SUBJECT: ISSUANCE OF AMENDMENT NO. 5 TO FACILITY OPERATING LICENSE
NO. DPR-72 FOR CRYSTAL RIVER UNIT 3 NUCLEAR GENERATING
PLANT

CRYSTAL RIVER UNIT 3 NUCLEAR GENERATING PLANT

Amendment No. 5
 License No. DPR-72

SAFETY EVALUATION BY THE OFFICE OF NUCLEAR REACTOR REGULATION

Figure 6.2-1 Offsite Organization

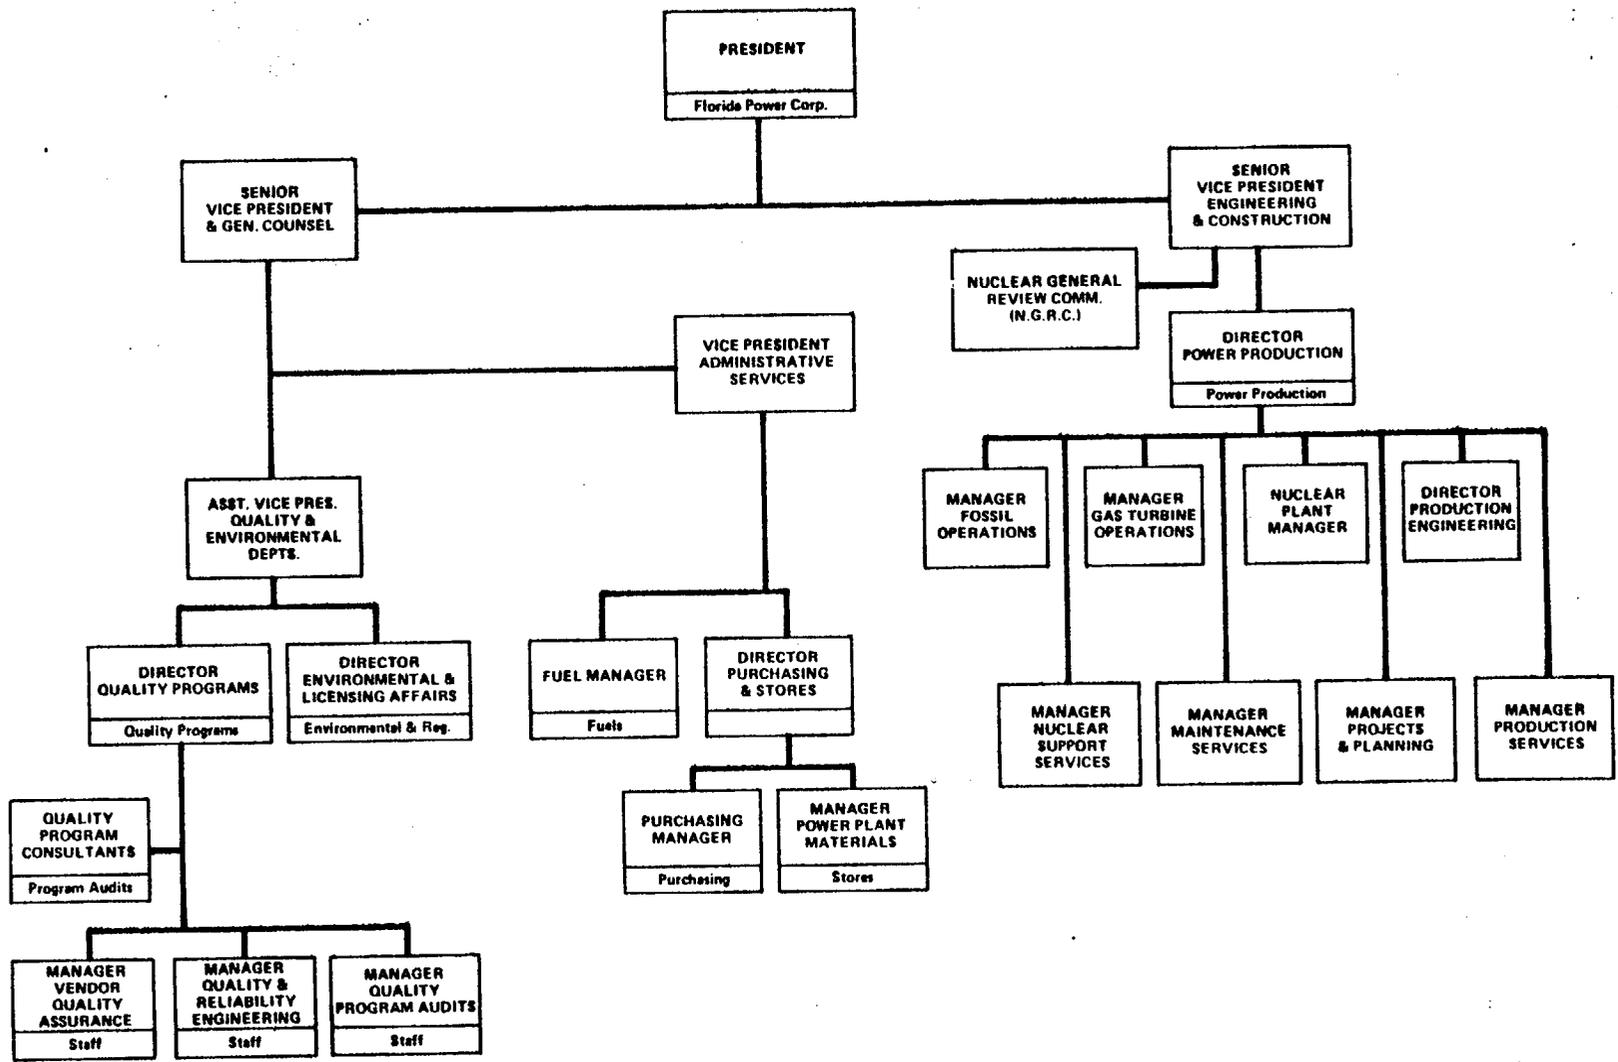
With regard to the revisions in the offsite organization for technical support and facility management, Florida Power Corporation has reorganized the management at the corporate level such that the Director of Power Production now reports directly to a new management position of the Senior Vice President - Engineering and Construction. At the plant staff level the previous titles of Nuclear Plant Superintendent and Assistant Plant Superintendent have been changed to Nuclear Plant Manager and Assistant Plant Manager, respectively.

6.2.1 The offsite organization for facility management and technical support shall be as shown on Figure 6.2-1.

We evaluated the proposed changes in the offsite organization for technical support and facility management incurred by corporate management changes and have determined that these changes do not adversely affect the lines of authority of the plant manager nor the technical support for operation of the plant. The change in titles at the plant level have not resulted in any deletion of responsibility or authority at the plant level. The Nuclear Plant Manager (previous title was Nuclear Plant Superintendent) reports to the Director-Power Production. This functional relationship remains unchanged. We therefore have determined that these changes in offsite organization and management titles are acceptable.

Figure 6.2-2 Facility Organization

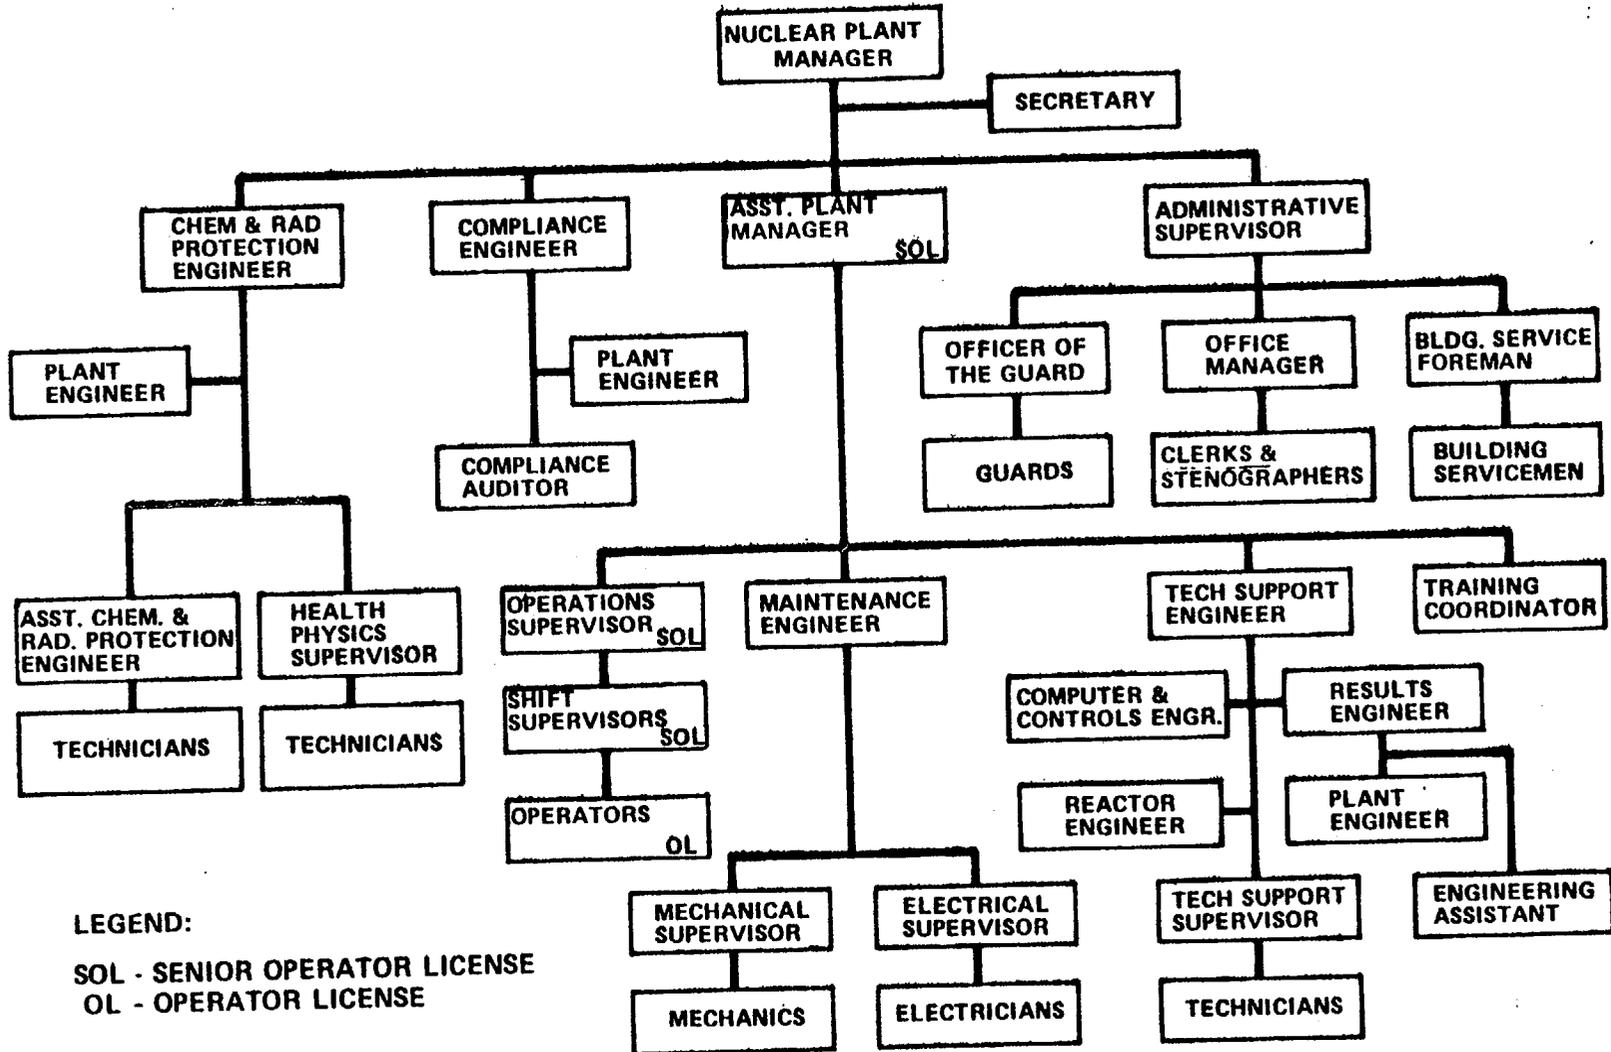
6.2.2 The Facility organization shall be as shown on Figure 6.2-2 and:
